FCC ID: RSNTRIFLEX-2GO-V

CT Project: P1410003

From: Daniel Park

Date: 2/12/14

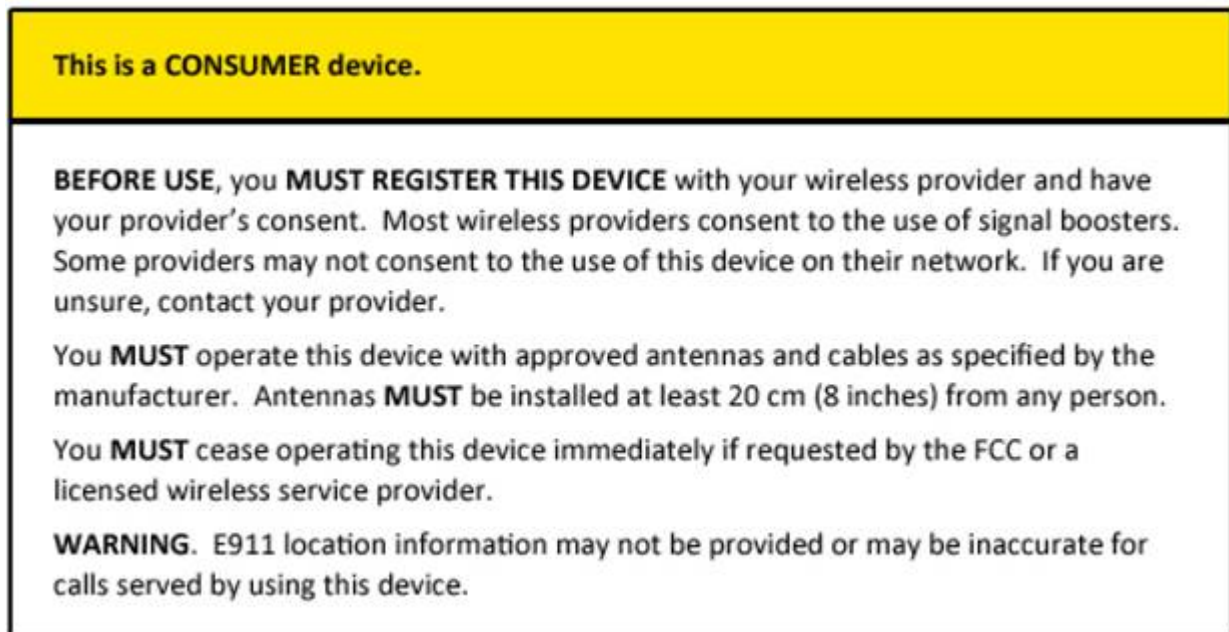
3. Please provide higher resolution photos for the label related exhibits. Especially, the exhibit shows FCC warning label as below.

Cellphone-Mate – Please refer to revised label exhibits.
